PROPOSED HIGHWAY PROJECT

JNU NORTH DOUGLAS - BONNIE BRAE - DEC 20 SE PR PROJECT NO. 0093002/SFHwy00411

As-Builts
Contractor: SECON
Project Engineer: Dillon Tomaro
Start Date: 7/14/23
End Date: 9/6/23

Record Drawings have been reviewed by the Project Engineer, and represent to the best of my knowledge, the project as constructed.

TYPICAL SECTIONS

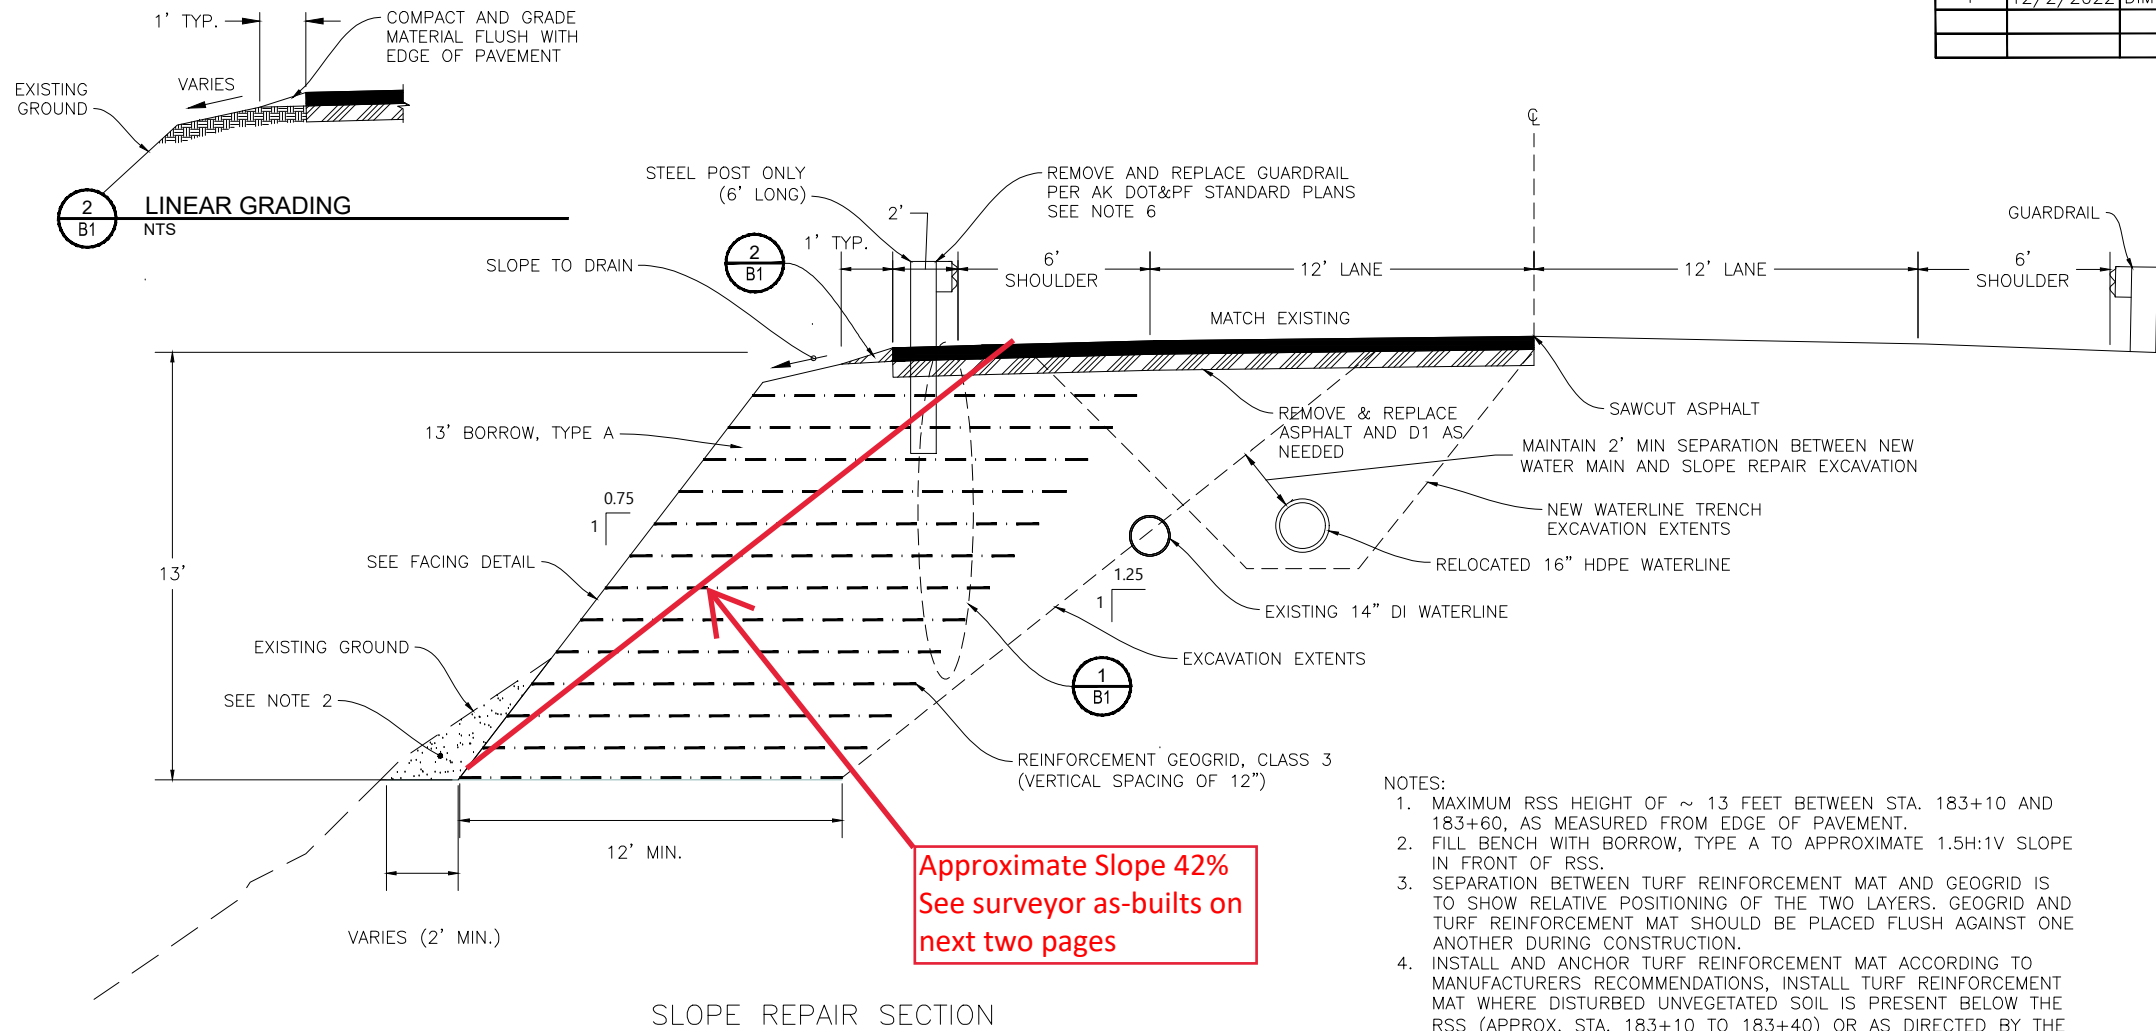
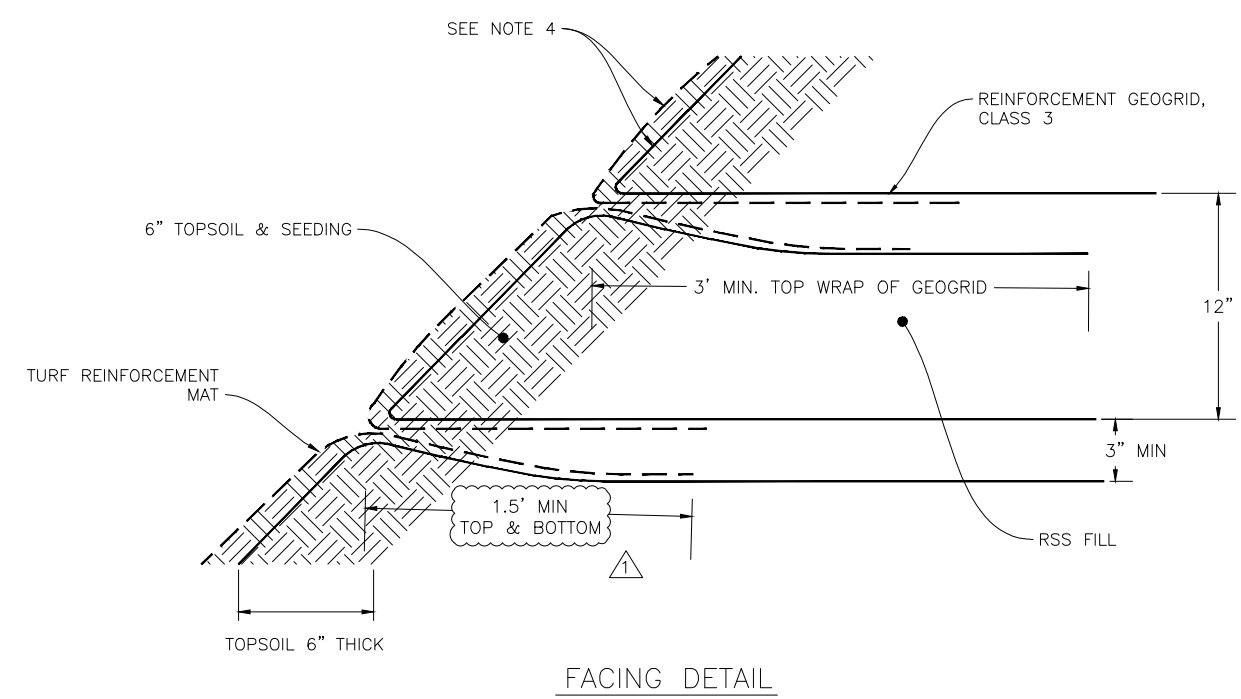
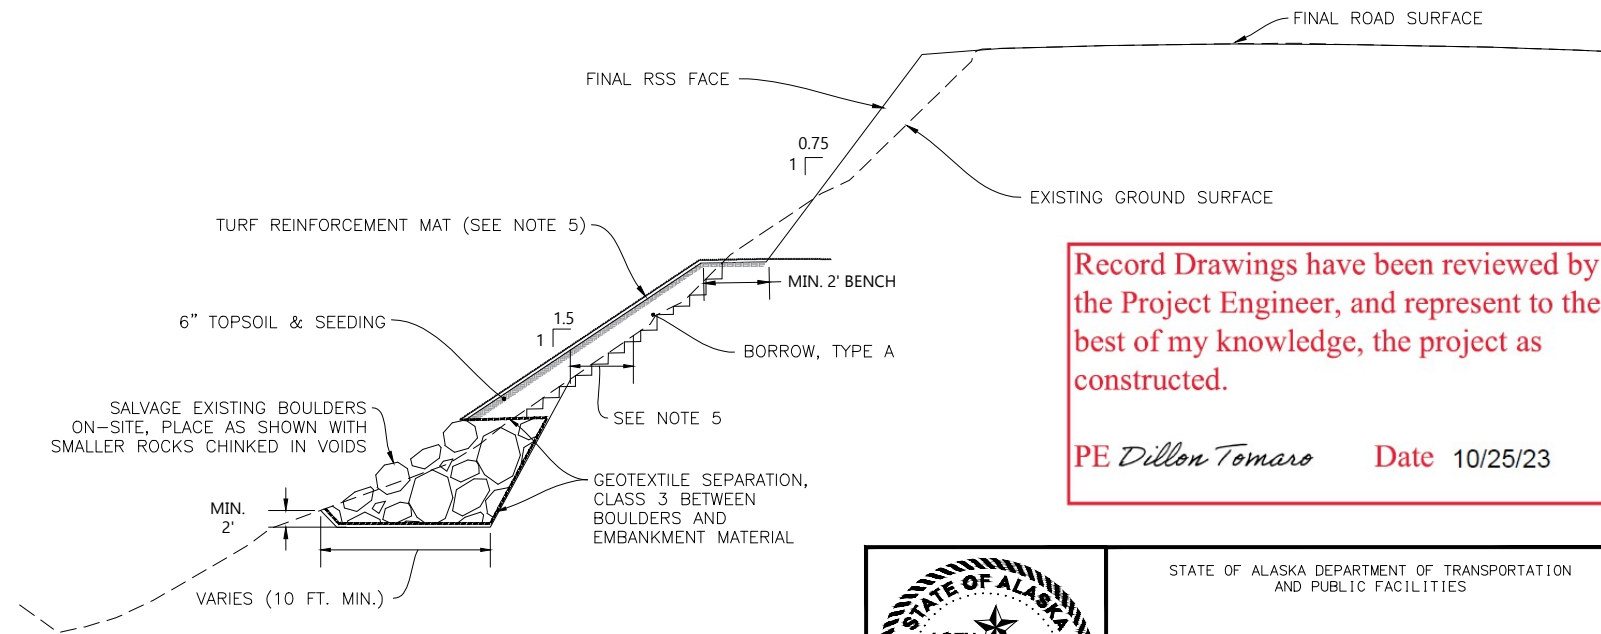
Approximate Slope 42%
 See surveyor as-builts on
 next two pages

PLAN AND PROFILE

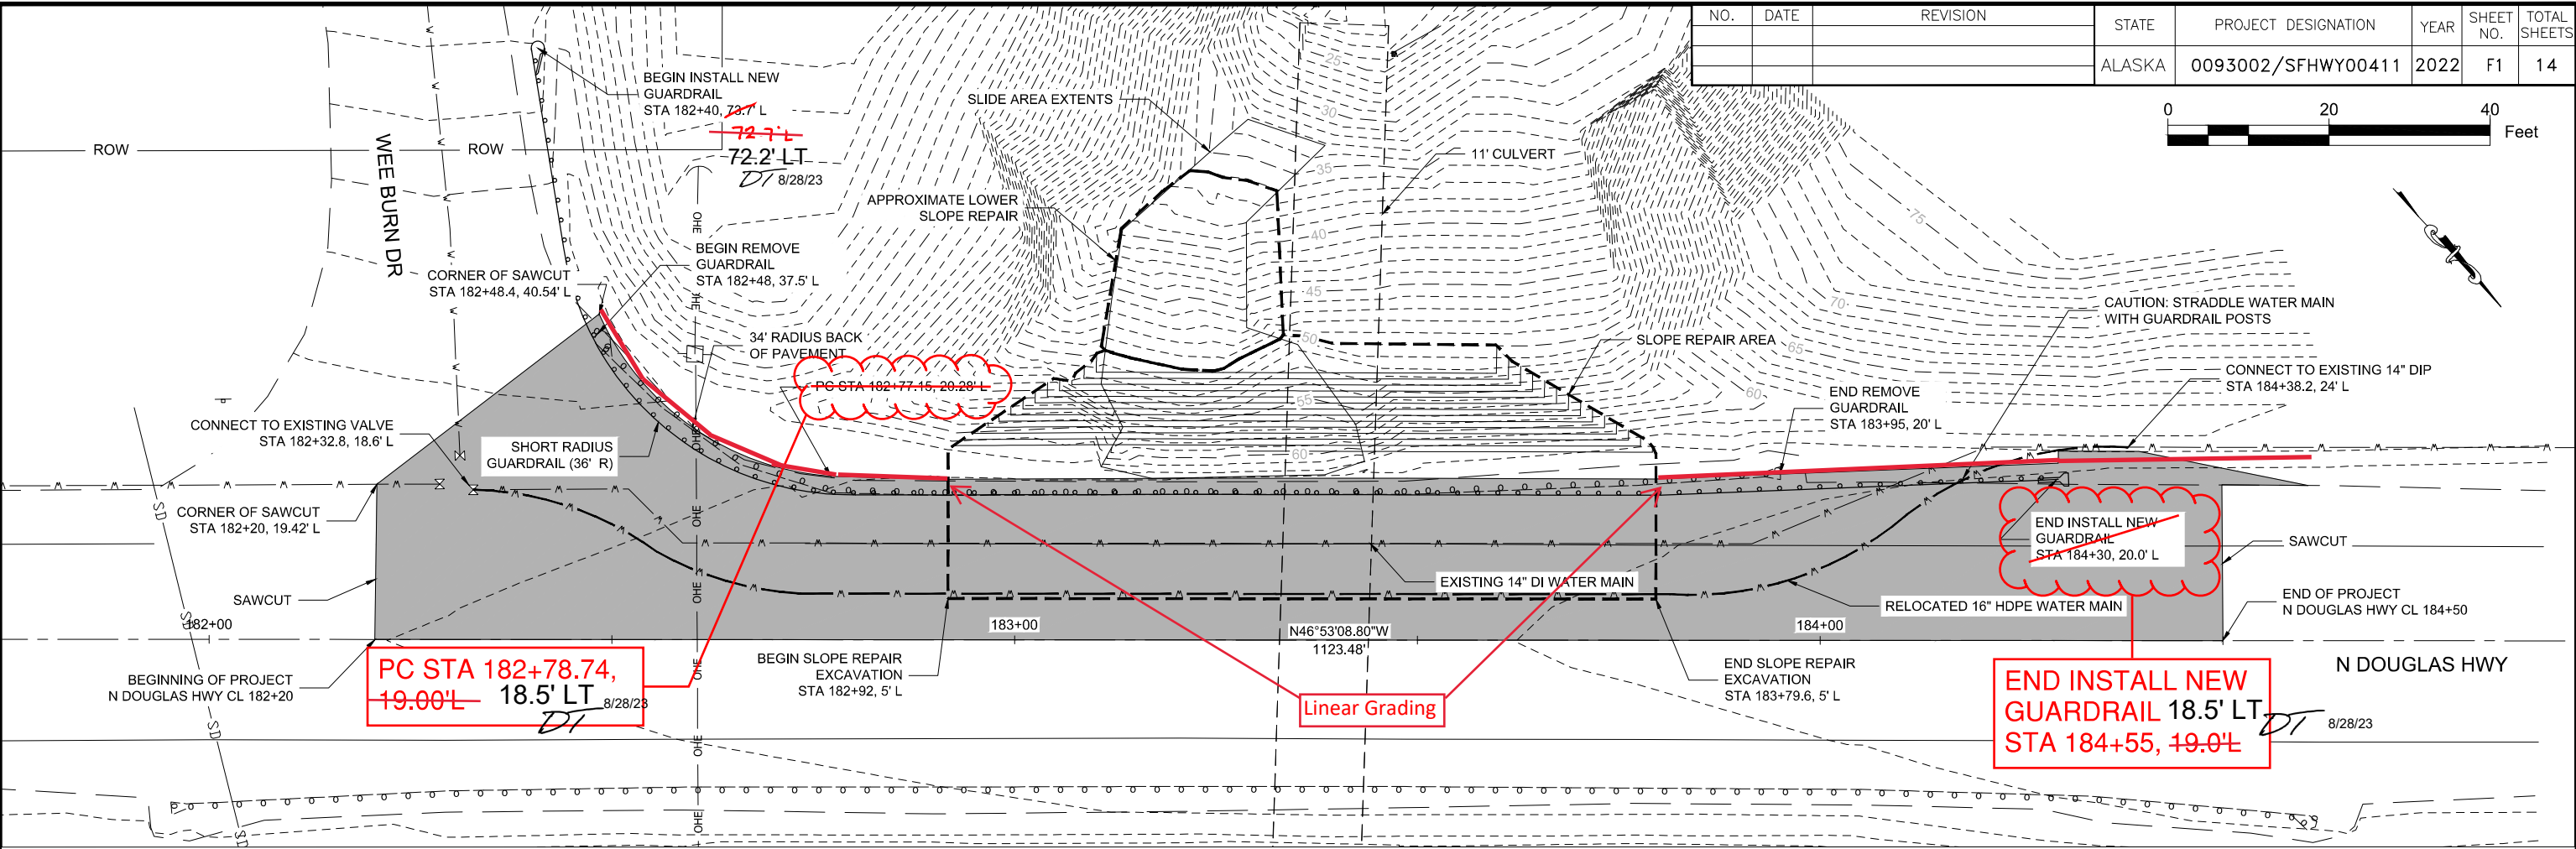
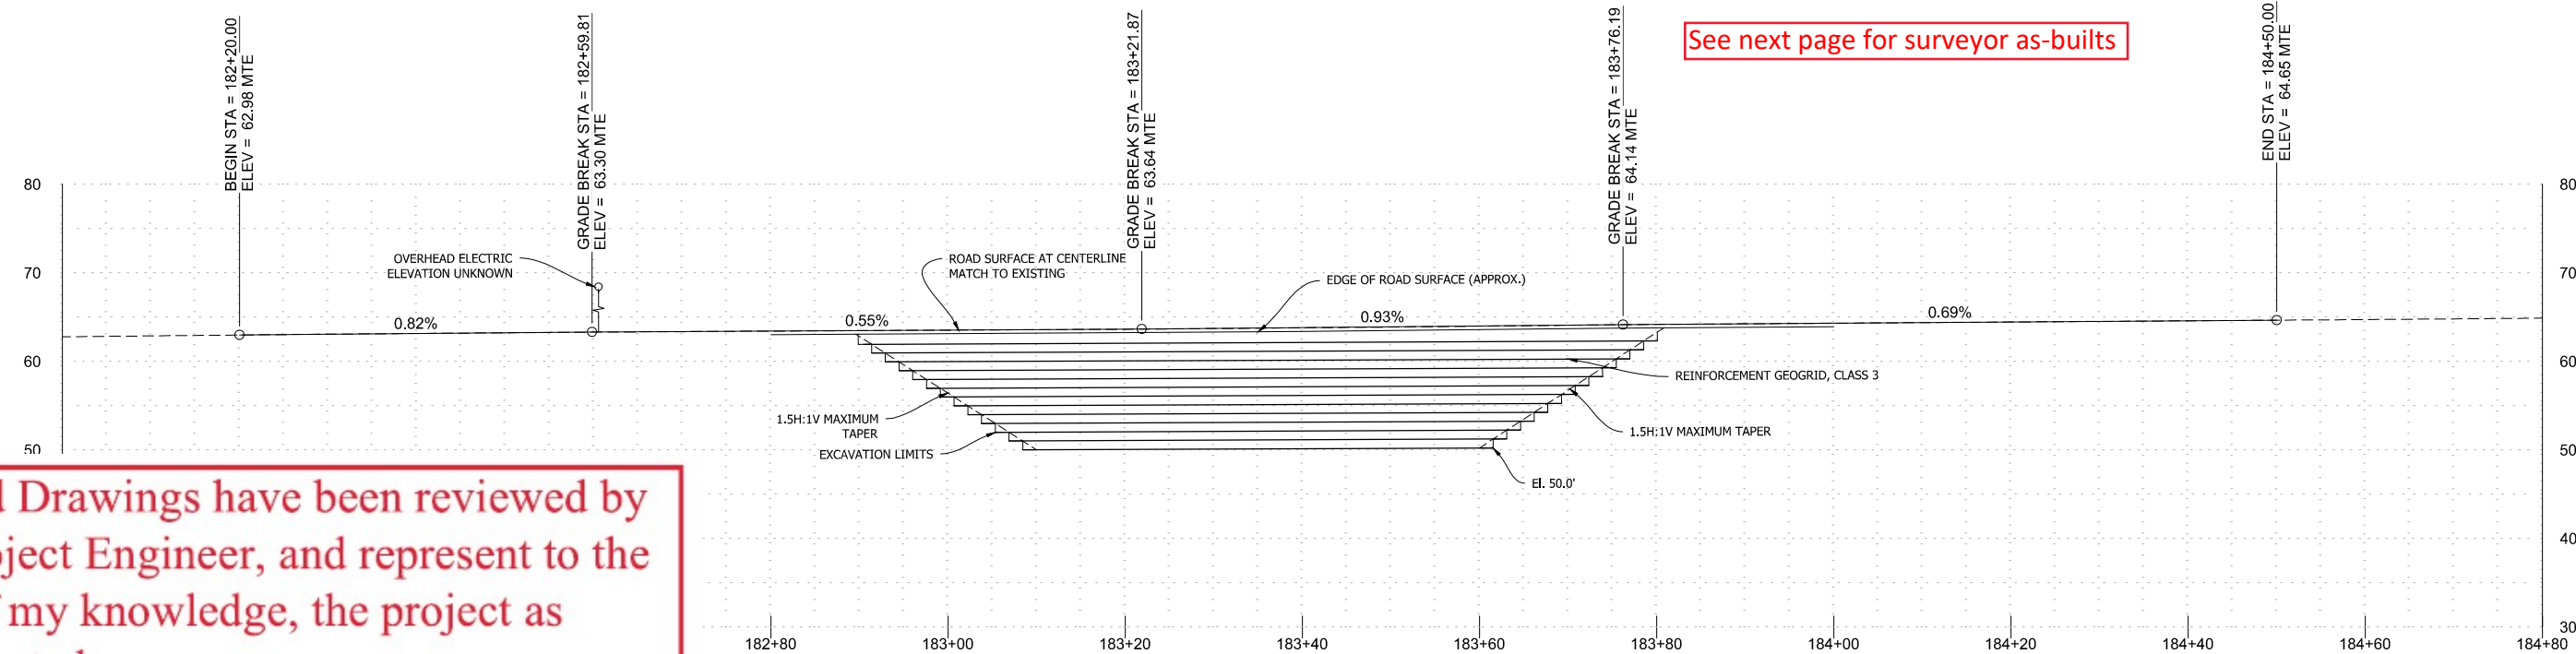
PC STA 182+78.74,
 19.00'L 18.5' LT
 DT 8/28/23

END INSTALL NEW
 GUARDRAIL 18.5' LT
 STA 184+55, 19.0'L
 DT 8/28/23

See next page for surveyor as-builts

TCP NOT SEALED IN ACCORDANCE WITH ALASKA HIGHWAY RECONSTRUCTION MANUAL SECTION 1400.3.5 DATED JANUARY 20, 2012	STATE OF ALASKA DEPARTMENT OF TRANSPORTATION AND PUBLIC FACILITIES
	JNU NORTH DOUGLAS - BONNIE BRAE - DEC 20 SE PR
	CONSTRUCTION PHASING PLAN

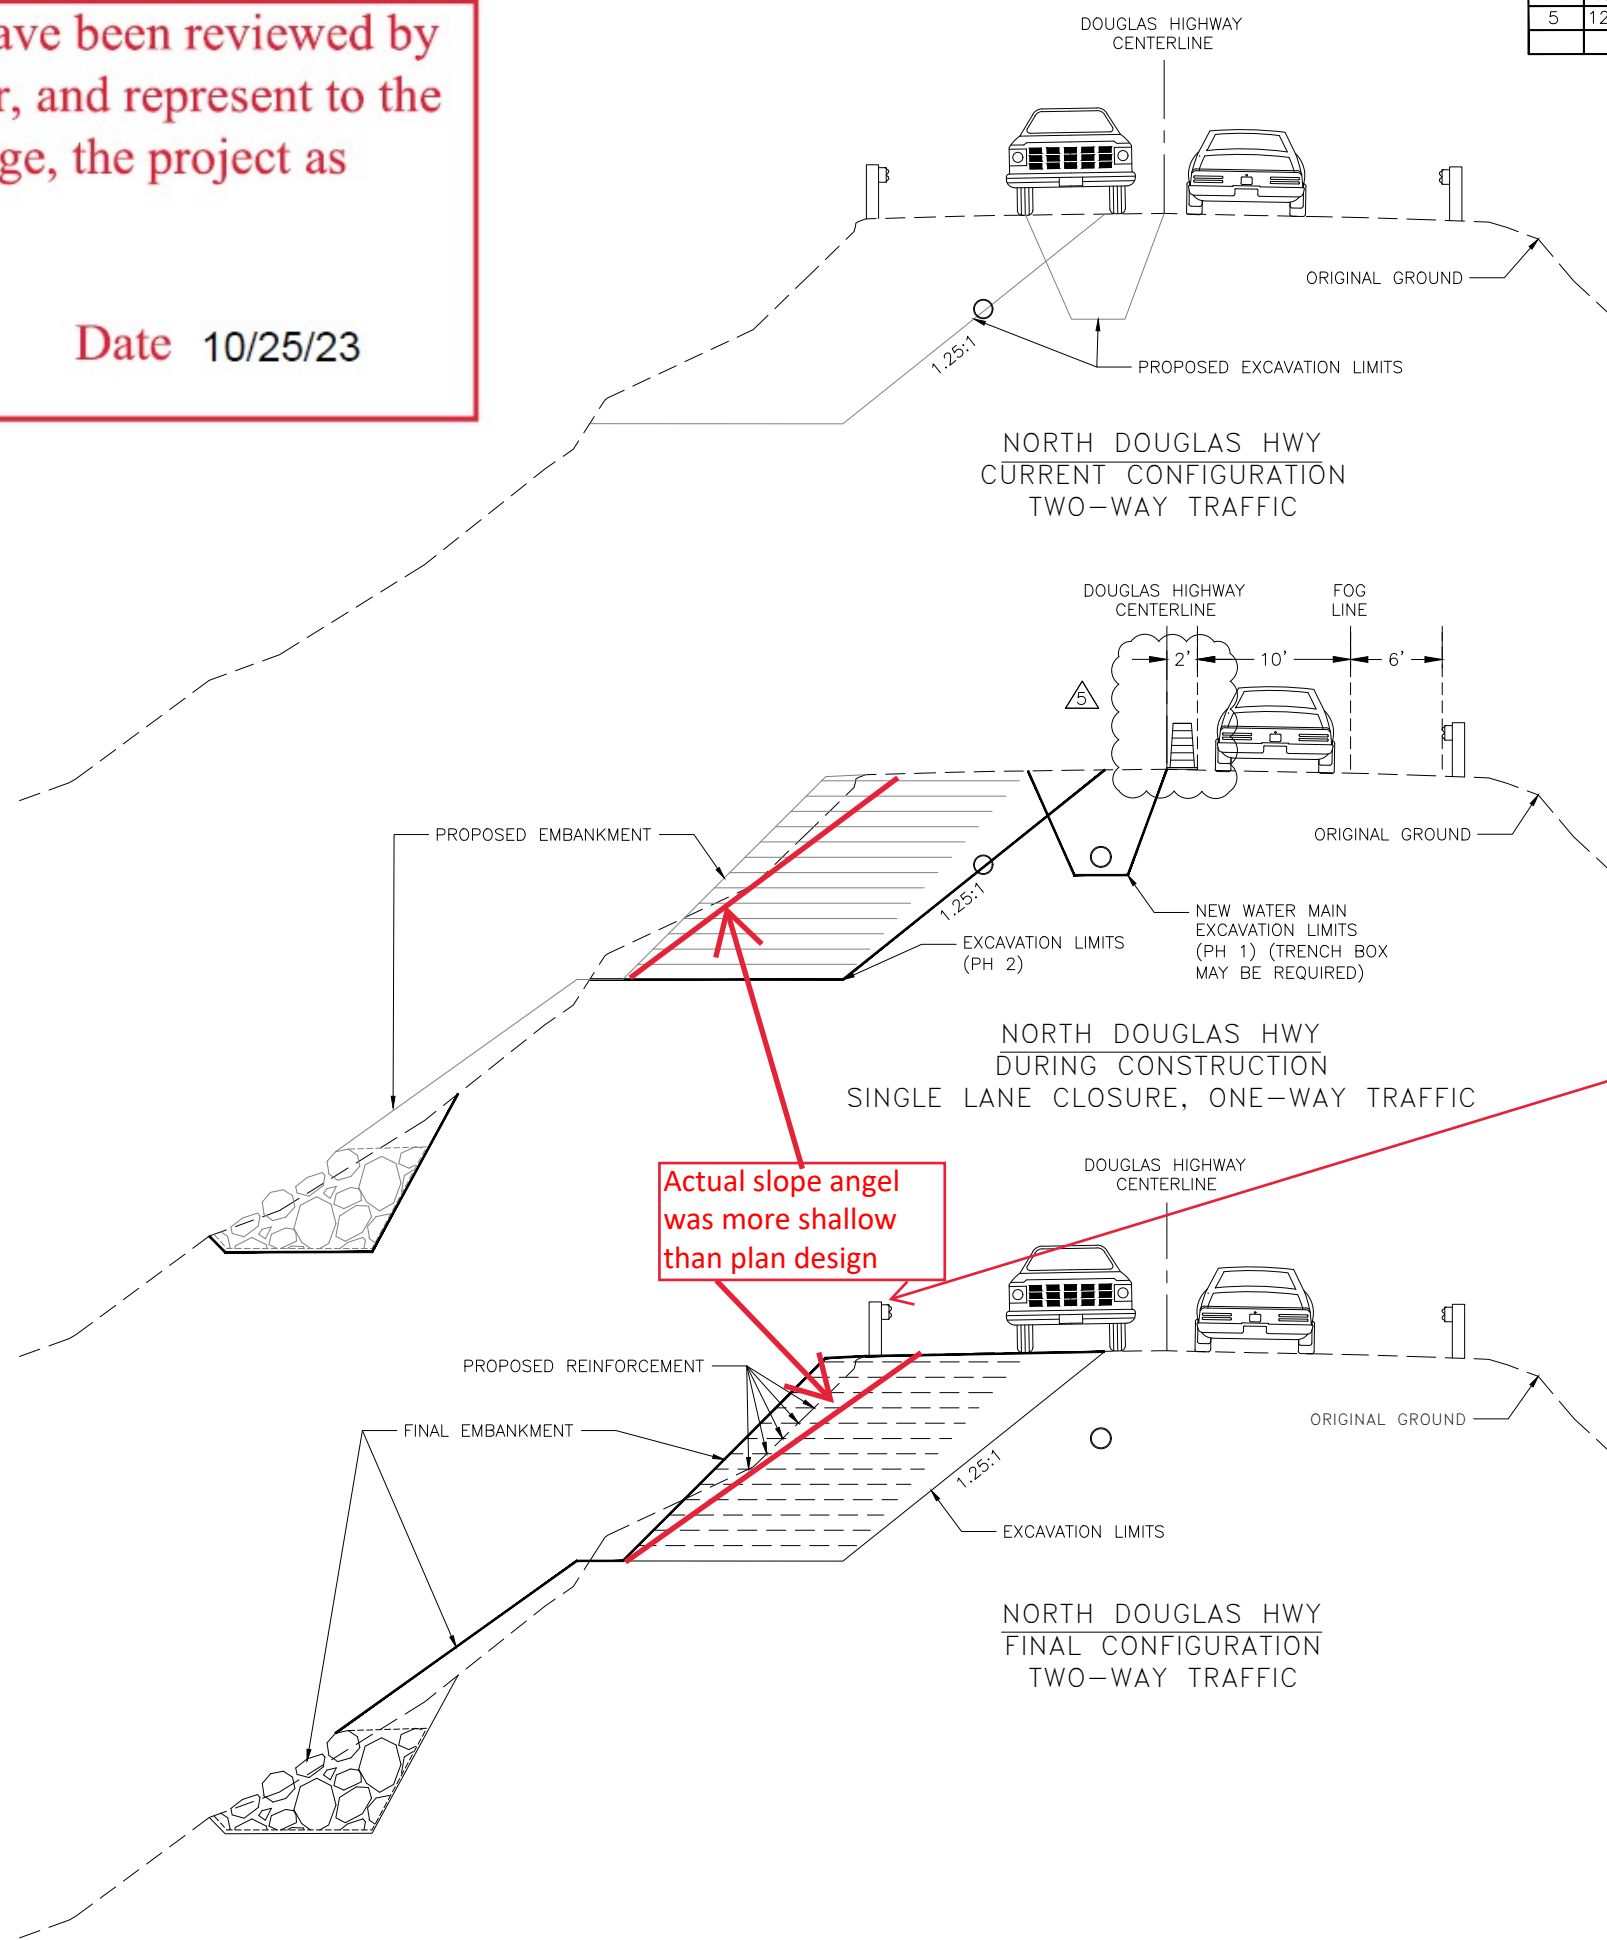
Guardrail posts with a face of guardrail and slope distance of 2' to 3.5' were driven with 8' posts in accordance standard plans sheet G-10.21 Case 2.

Actual slope angel was more shallow than plan design
